UNITED STATES PATENT AND TRADEMARK OFFICE

Office Action Summary	Application No. 10/584,937	Applicant(s) AHN, JOON-YOUNG	
	Examiner KAREEN RUSH	Art Unit 3781

DETAILED ACTION

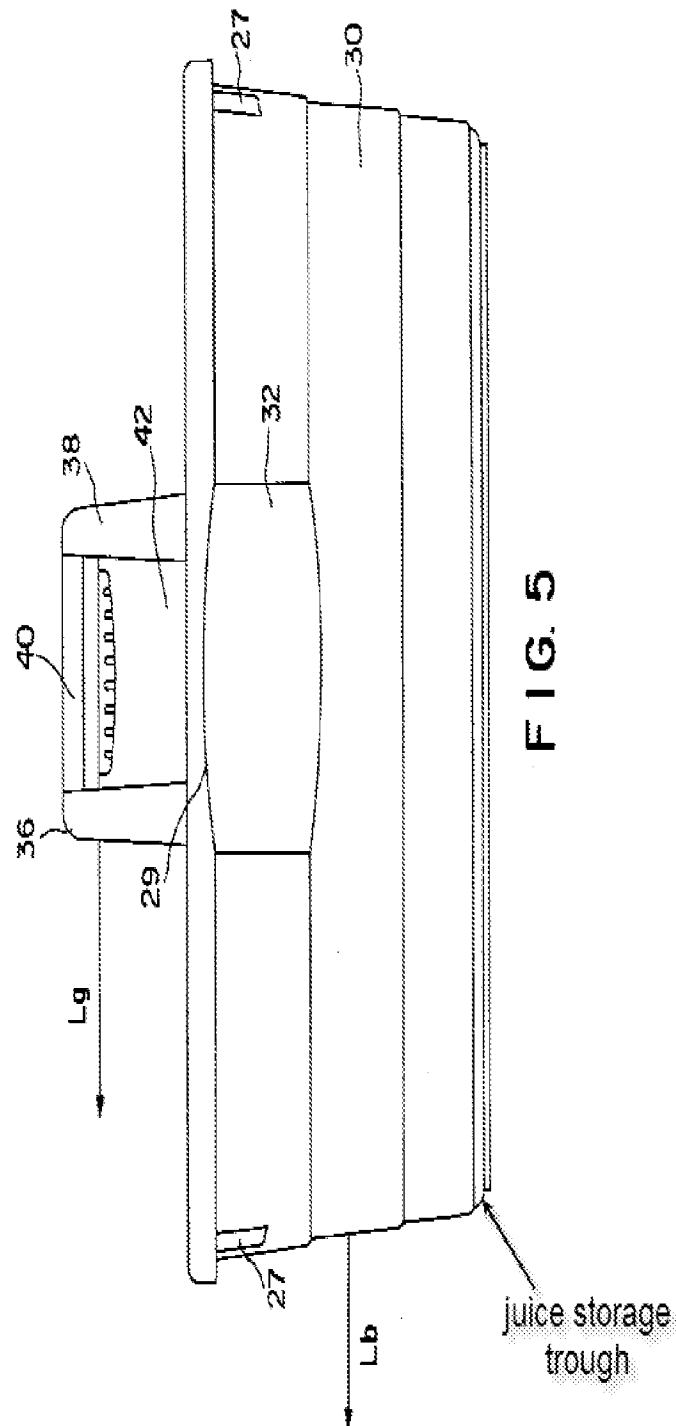
a. Regarding claim 1, Flink teaches a container (Fig. 6) for a **vaccum packing**, comprising of a base panel (in the below annotated Fig. 6) to be put into a vaccum bag (the container can be but into a vaccum bag), with an item to be packed being laid on the base panel (items are intended to be laid on the base) and a front panel (in the below annotated Fig. 6) provided at a front position of the base panel with an air hole (Fig. 6 at 25) formed on the front panel.

b. Regarding claim 2, Flink teaches an embossment (Fig. 6 at 24) is provided on the base panel to define an air discharge path.

c. Regarding claim 5, Flink teaches a first guide panel (in the below annotated Fig. 6) extends outward from a position above the air hole to a predetermined position, and a second guide panel (in the below annotated Fig. 6) extends outward from a position under the air hole to a predetermined position.

- d. Regarding claim 6, Flint teaches a juice storage trough is provided at a position around the base panel (in the below annotated Fig. 6 and 5; the base of Fig. 5 is the base used in Fig. 6)

- e. Regarding claim 8, Flink teaches a first guide panel (in the below annotated Fig. 6) extends outward from a position above the air hole to a predetermined position, and a second guide panel (in the below annotated Fig. 6) extends outward from a position under the air hole to a predetermined position.

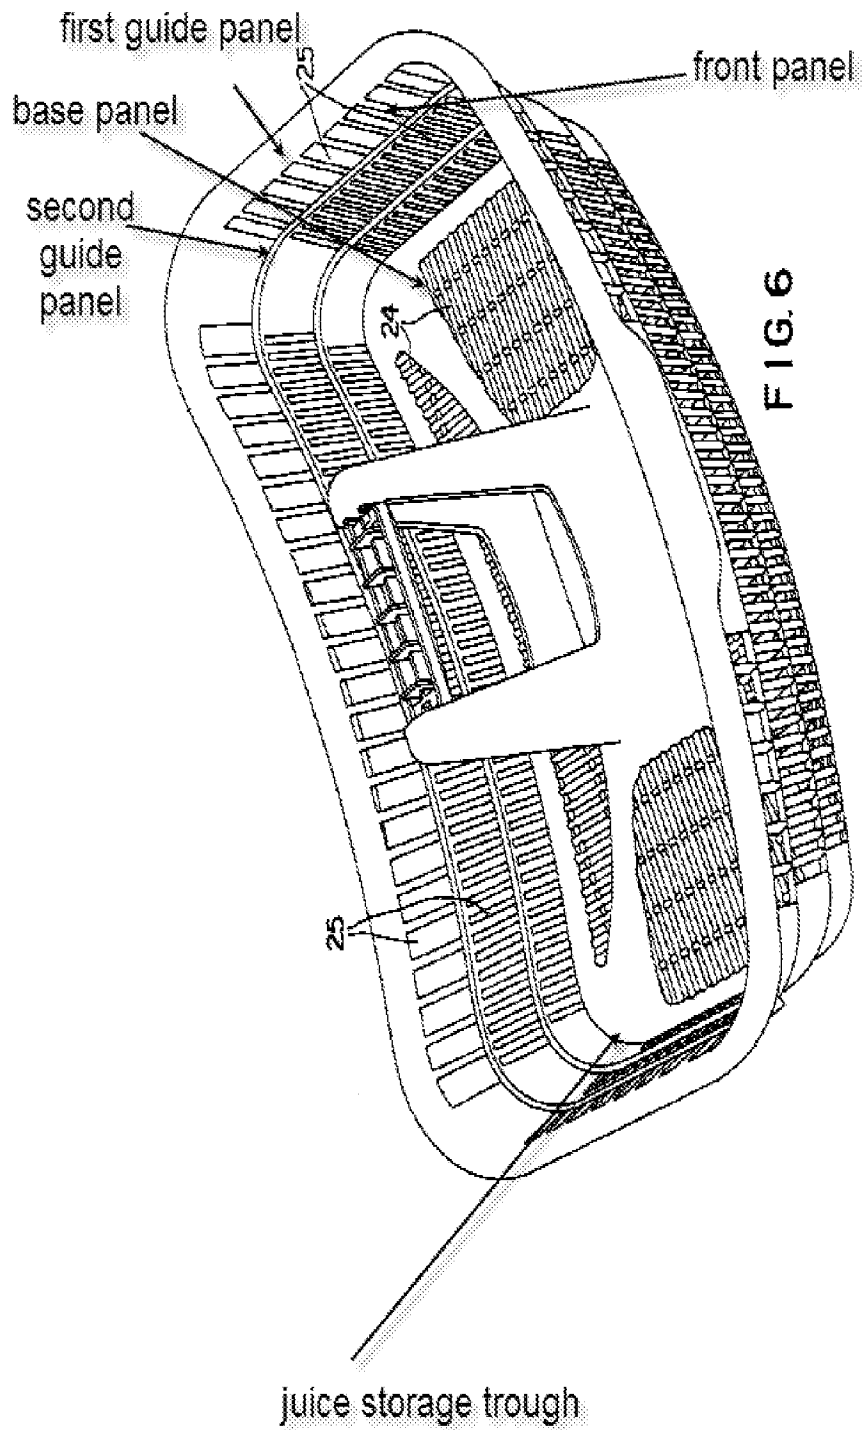
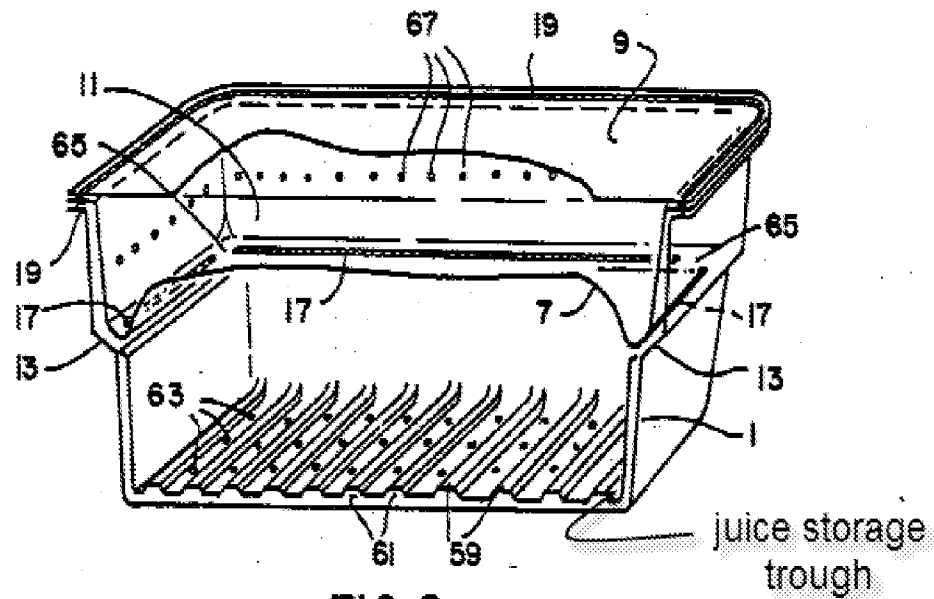
- i. Regarding claim 2, Meehan teaches an embossment (in the below annotated Fig. 1) is provided on the base panel to define an air discharge path.
- j. Regarding claim 4, Meehan teaches the base panel is adjustable in length (as can be seen in Fig. 5 with the removal of member 50).
- k. Regarding claim 7, Meehan teaches the base panel is adjustable in length (as can be seen in Fig. 5 with the removal of member 50).

FIG. 8

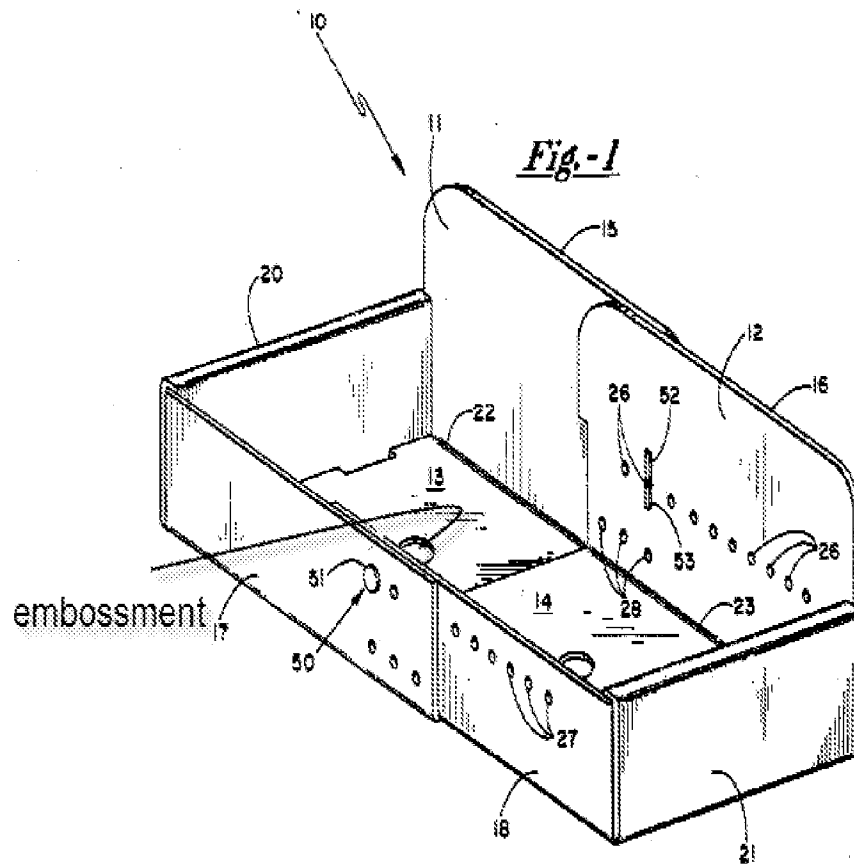
- g. Regarding claim 3, Garwood teaches a juice storage trough (in the below annotated Fig. 8) is provided at a position around the base panel.
4. Claims 1, 2, 4 and 7 are rejected under 35 U.S.C. 102(b) as being anticipated by Meehan (5192019).
